ADDENDUM to the TD: “the supply of 32 SLICES CT SCANNER WITH RELATED EQUIPMENTS _RWA19008-10007”

Please find below, the clarifications to the received requests as well as some modifications on the terms of the TD

REVISED DESIGN

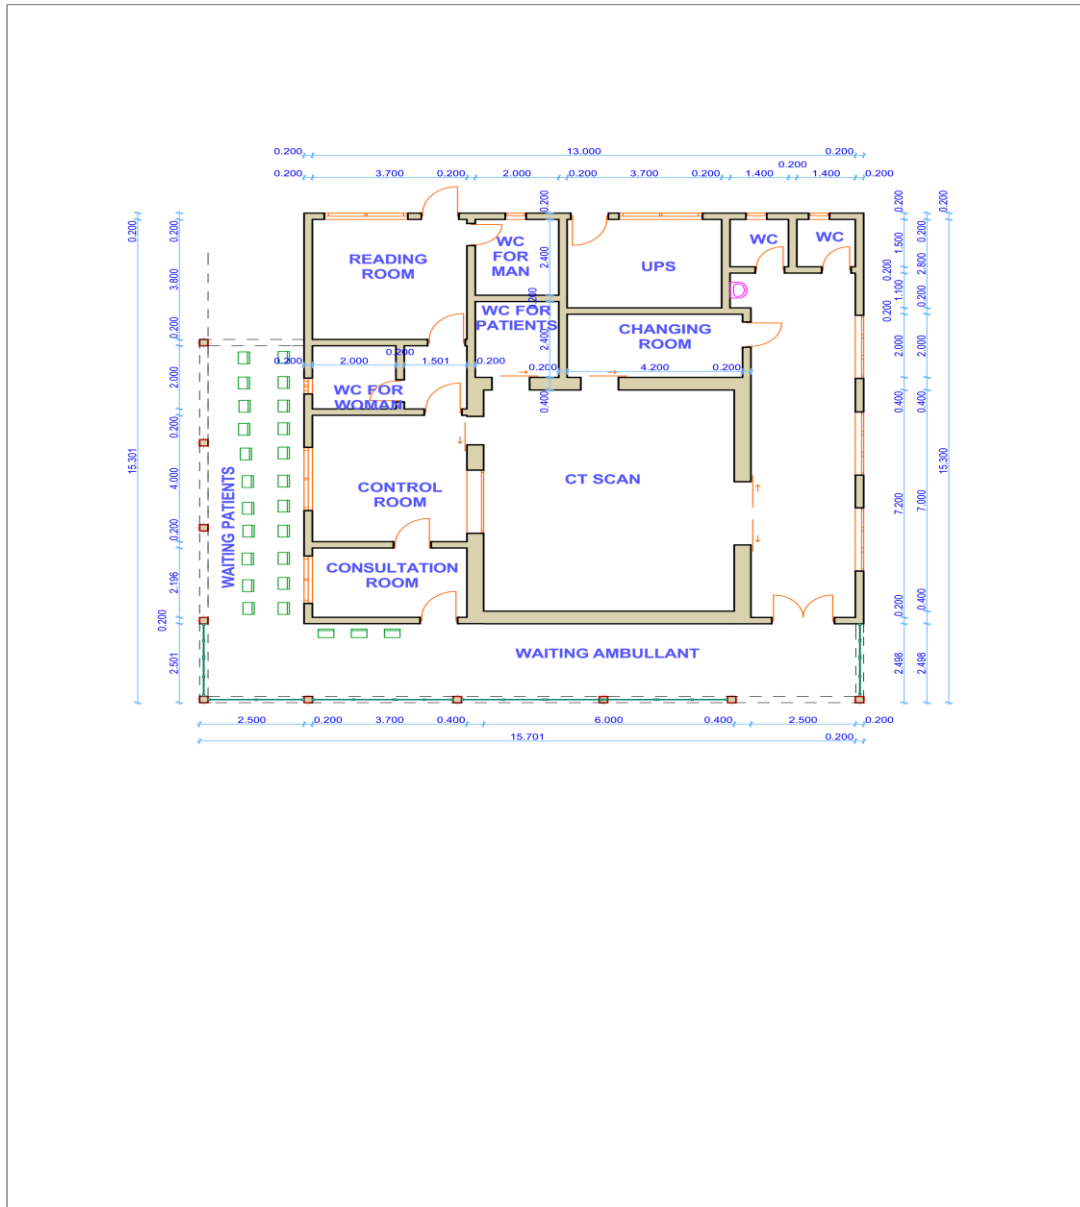
Discussed issues	Action / Recommendations or Proposed Solutions
<p style="text-align: center;"><u>Location of the CT room on the design</u></p> <p>The team discussed about the relocation of CT room and change the design for the purpose of radiation protection to the patient.</p> <p><u>Site tour</u></p> <p>After the site tour these are the findings works done are:</p> <ul style="list-style-type: none"> • Fencing is done. • Foundation preparation is ongoing 	<p>Based on the ground conditions the CT room position cannot be changed we decided to extend the waiting area to avail a free space for ambulance trolleys.</p> <p>Reading room should have the exit door to avoid the saturated flow of the staff; WC for staff should be separately for men and women and the lead sliding doors will be added as</p>

it is mentioned on the design below which can increase the amount planned.
